## CORRIGENDUM - 02 TO NIT NO-84687

**Subject: Corrigendum-02 to Tender enquiry for Pre-Bid Tie up with the GIS OEM for Supply & Services of 220 kV GIS for IOCL's Panipat 220kV GIS S/stn Tender / Project.**

**Ref. No.**      **Technical Corrigendum-01**

**Project:**      **Pre-Bid Tie up for,  
EPCC 03 Package 220KV GIS AND ASSOCIATED WORKS for Maleic Anhydride Project at Panipat Refinery Petrochemical Complex of M/s.  
Indian Oil Corporation Limited.t**

DEAD END TOWER  
220 KV LINES

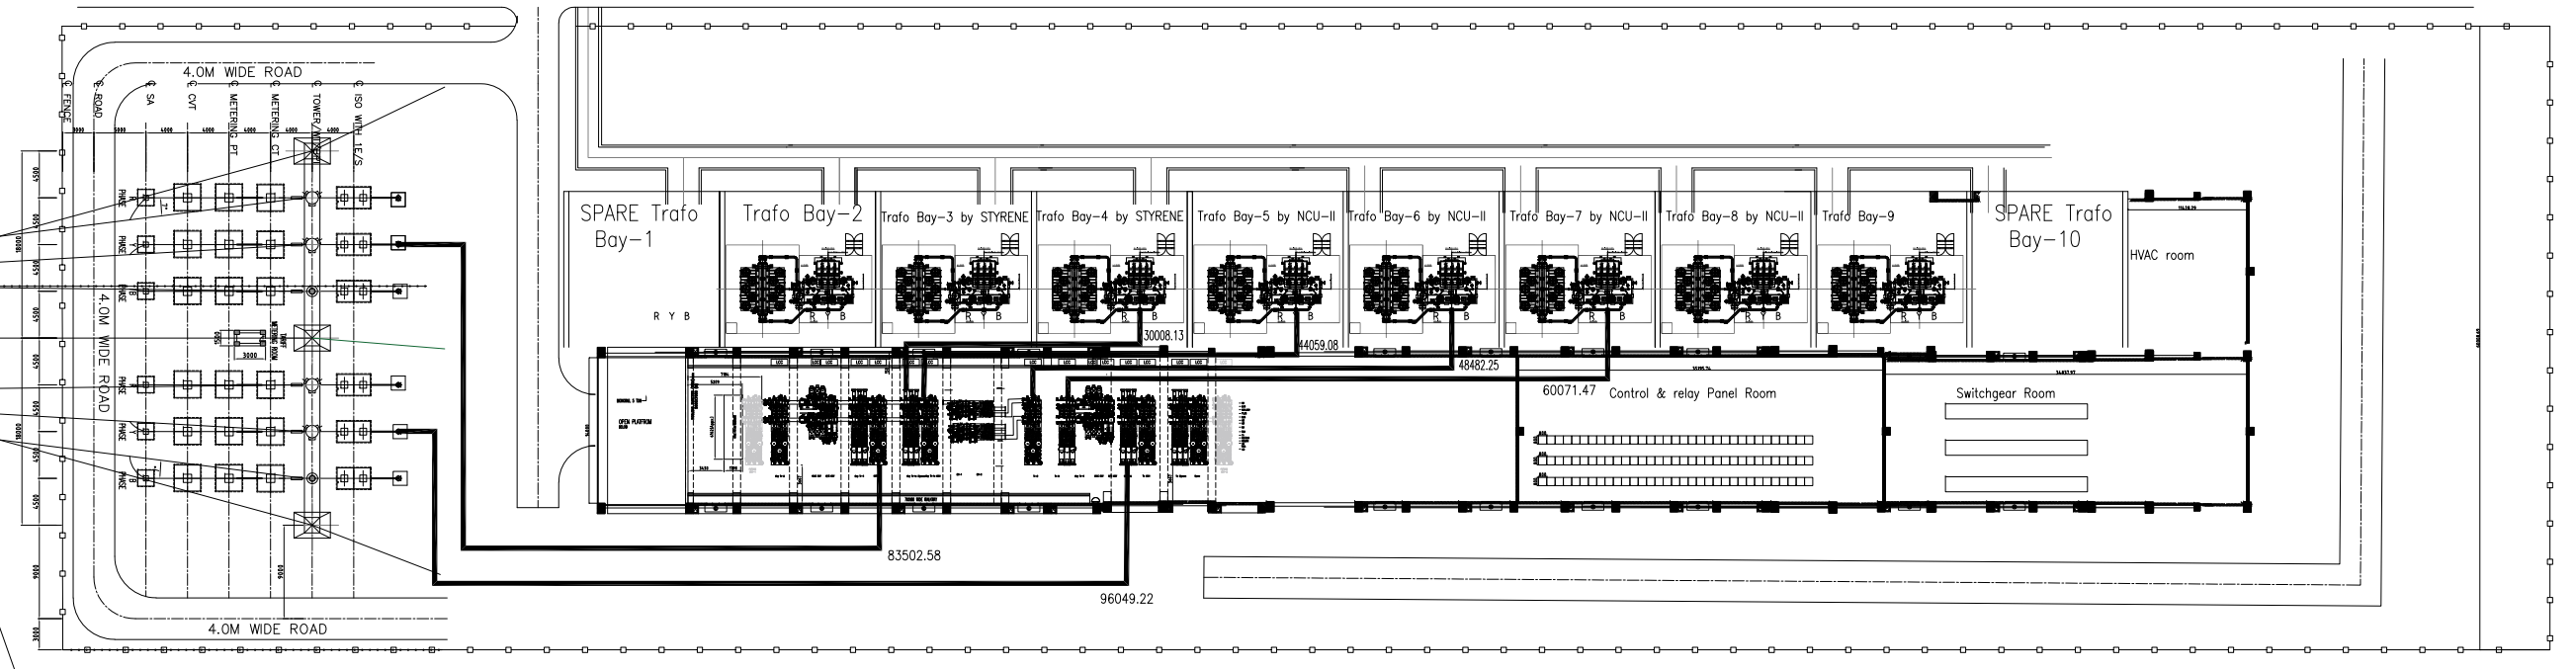
Sl. No.	Volume/ Section/ Clause	Volume/ Section/ Clause as Existing	Volume/ Section/ Clause as Amended/ Added in Technical Corrigendum-01
2	'Technical Specification/ Section-1	Please refer Section-1 of Technical Specification/ Bill of Quantities Annexure- BOQ_IOCL	BOQ_220kV GIS_SUPPLY_IOCL PANIPAT & BOQ_220kV GIS_SERVICES_IOCL PANIPAT (Please refer revised BOQ).
3	'Technical Specification/ Section 1	Please refer Technical Specification/ Single Line Diagram REV00	Please refer Technical Specification/ Single Line Diagram REV00 with additional details (Please refer the document).
4	Technical Specification/ section-1	Please refer Technical Specification/ Tentative Layout Drawing	Please refer Technical Specification/ Tentative Layout Drawing with additional details (Please refer the document).
